SUNDRY NOTICES AND REPORTS ON WELLS (DO NOT USE THIS FORM FOR PROPOSALS TO DRILL OR TO DEEPEN OR PLUG BACK TO A DIFFERENT RESERVOIR. USE "APPLICATION FOR PERMIT" (FORM C-101) FOR SUCH PROPOSALS.)		WELL API NO. 30-025-09053

3. Address of Operator 600 TRAVIS ST., SUITE 5100 HOUSTON, TEXAS 77002		7. Lease Name or Unit Agreement Name SEVEN RIVERS QUEEN UNIT ✓
4. Well Location Unit Letter <u>G</u> : <u>1980</u> feet from the <u>NORTH</u> line and <u>1980</u> feet from the <u>EAST</u> line Section <u>27</u> Township <u>22S</u> Range <u>36E</u> NMPM LEA County		8. Well Number <u>007</u> ✓

SEVEN RIVERS QUEEN UNIT #007 (309557)

PROPOSAL TO PLUG AND ABANDON

Well Name: SEVEN RIVERS QUEEN UNIT 7

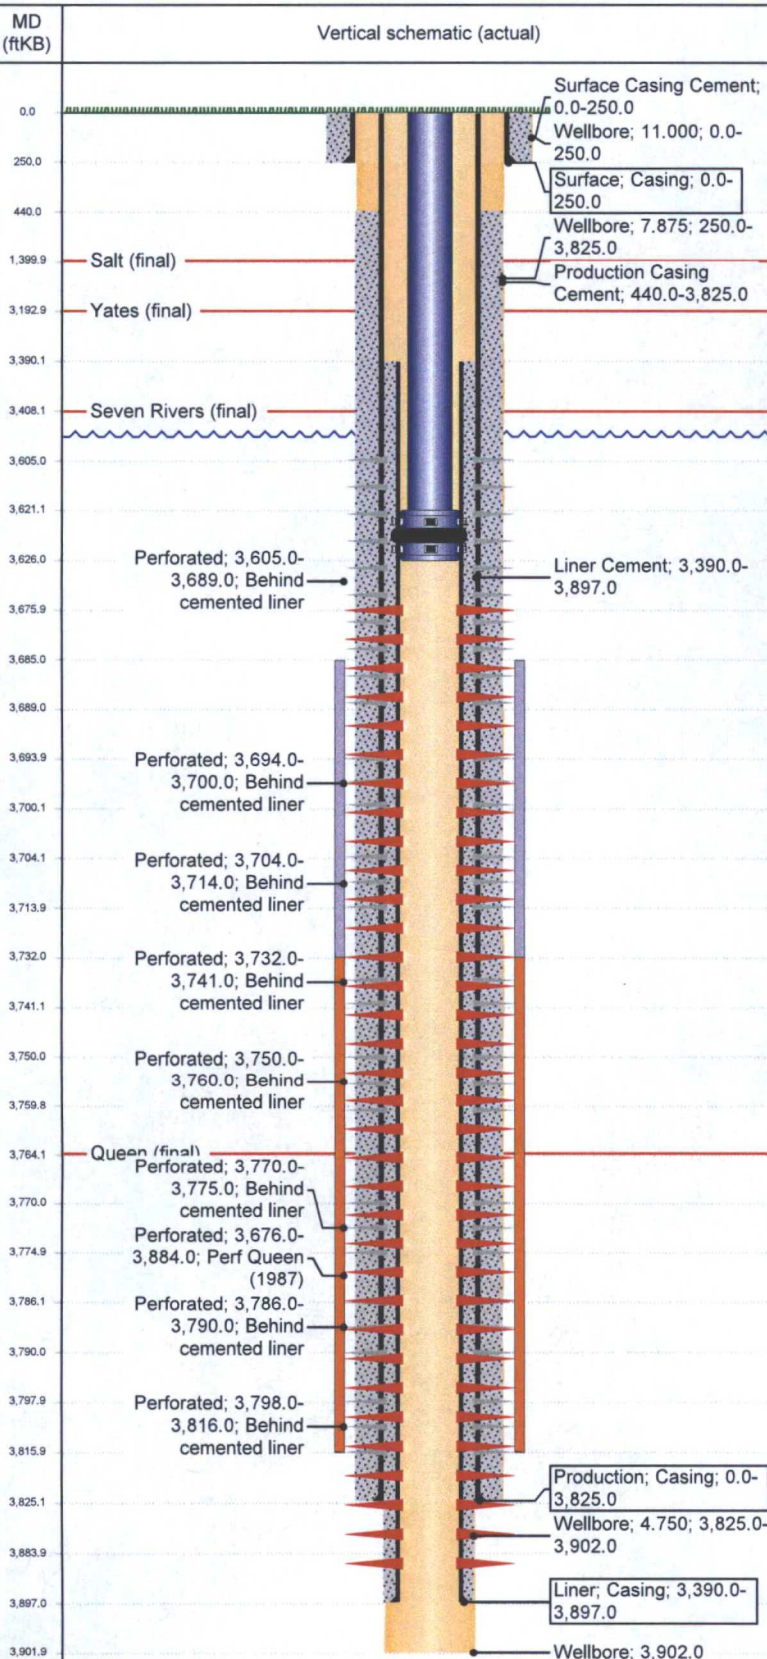
SQZ top of liner w/25sx. Displace to 3300'. WOC & TAG

1. Set 5-1/2" CIBP @ ^{3280'} 3385' w/25 sxs cmt
2. Circulate hole w/mud laden fluid. Pressure test csg. Report results
3. ~~Perf & Sqz~~ 25 sxs cmt @ 2950' - 2850'. WOC & Tag.
4. Perf & Sqz 25 sxs cmt @ 1400' - 1300'. WOC & Tag.
5. Perf & Sqz 125 sxs cmt @ 300' & circulate to surface.
6. Cut off wellhead and weld on Dry Hole Marker.

SPOT

Verify cement to surface.

Well Name: SEVEN RIVERS QUEEN UNIT 7

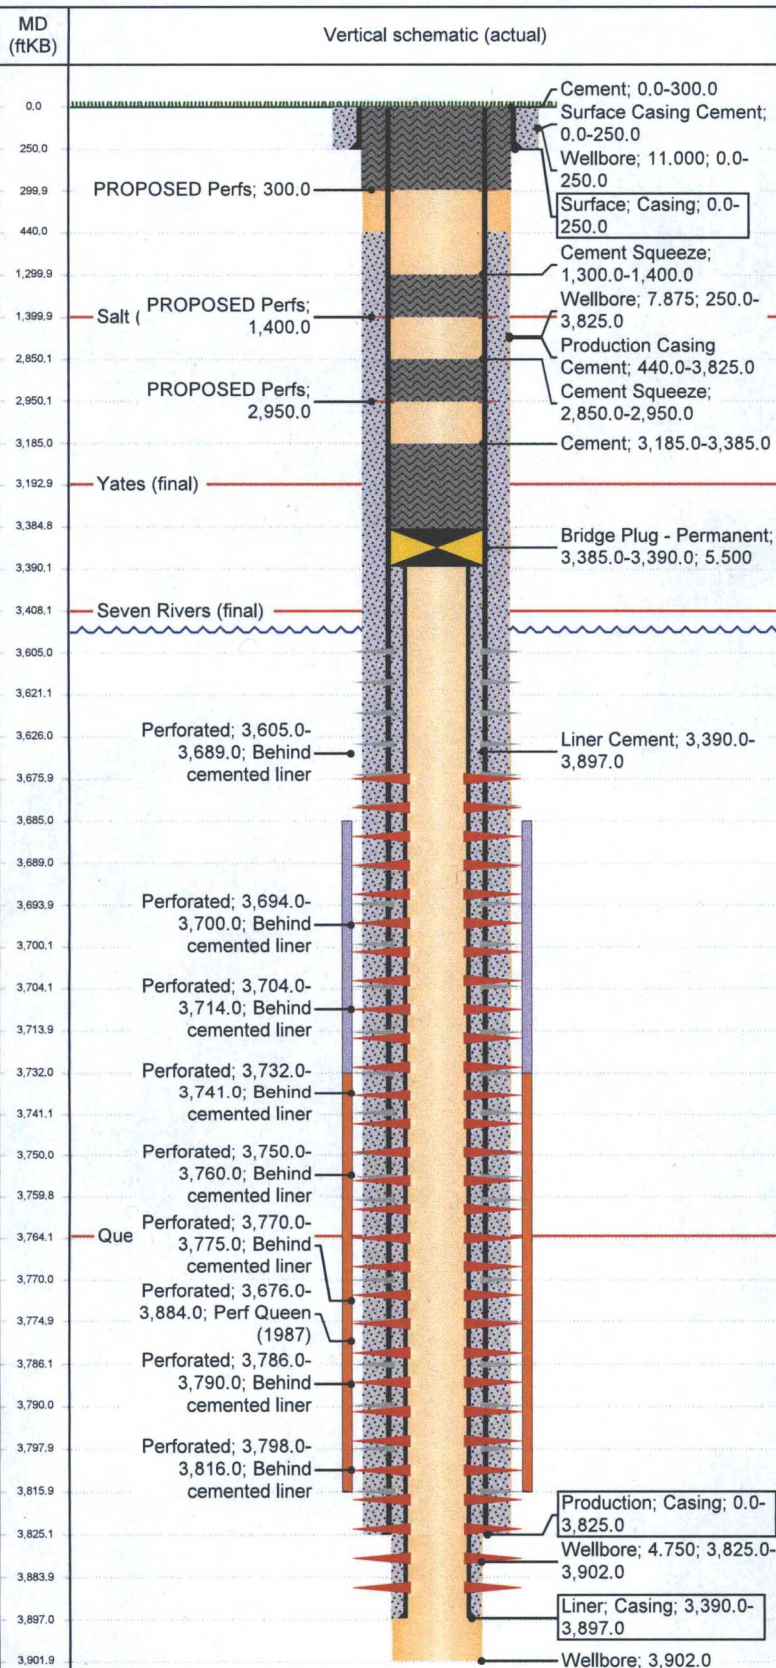
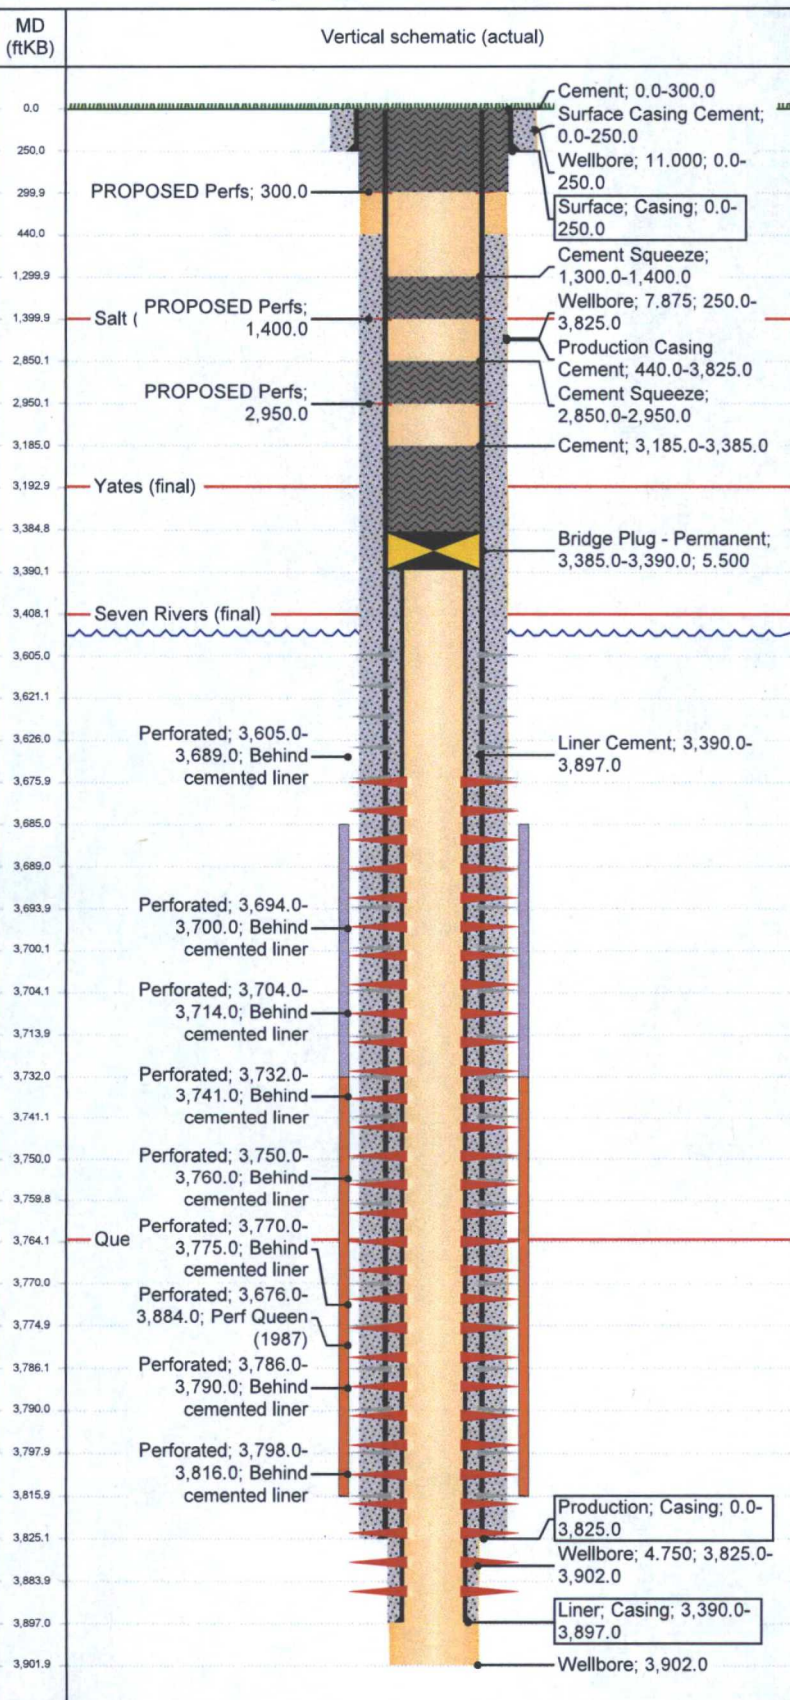
Description	Top (ftKB)	Btm (ftKB)	Eval Method	Comment
Cement Squeeze	3,185.0	3,385.0		PROPOSED: Cap CIBP w 25 sks cmt.
Cement Squeeze	2,850.0	2,950.0		PROPOSED: Perf & Sqz 25 sks cmt 2950'-2850'. Tag TOC.
Cement Squeeze	1,300.0	1,400.0		PROPOSED: Perf & Sqz 25 sks cmt 1400'-1300'. Tag TOC.
Cement Squeeze	0.0	300.0		PROPOSED: Perf & Sqz 125 sks cmt at 300'. Circ to surface.
Surface Casing Cement	0.0	250.0		Cmt'd w/ 250 sxs of regular neat cmt. Circ 50 sks to pit.
Production Casing Cement	440.0	3,825.0		Cmt'd w/ 1620 sxs. TOC at 440' (Temp Svy)
Liner Cement	3,390.0	3,897.0		Cmt liner w 75 sks cmt. Circ to TOL.

Des	Top (ftKB)	Btm (ftKB)	Run Date	Com
Bridge Plug - Permanent	3,385.0	3,390.0		PROPOSED: Set CIBP at 3385' and cap w 25 sks cmt.
